Access Compliance Report

Public Rights-of-Way

(Curb Ramps)

| Intersection ID: 22022 | Main Street: HAMPTONRIDGE_DR | Cross Street: HEATHSTEAD_PL | Location: NE |

| ADA ID: 34A1ED940C64 | Ramp Type: PerpDiag | Initial Pass/Fail: Fail | Overall Compliance: No |

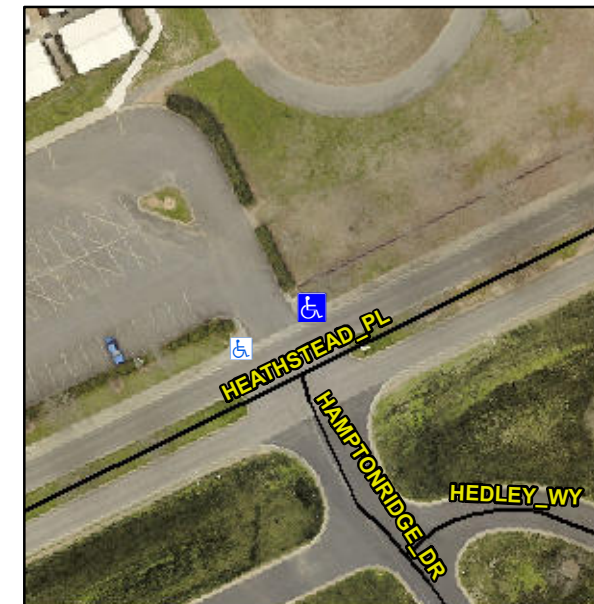
Not Found, R304.5.3

| Compliance | Description | Data | Compliance | Description | Data |
|------------|-----------------------|-------|------------|-----------------------------|-------|
| Yes | Ramp Width (in) | 50.0 | No | Ramp XSlope (%) | 5.1 |

Remove & Replace Curb Ramp With Two New Directional Ramps or Equivalent.
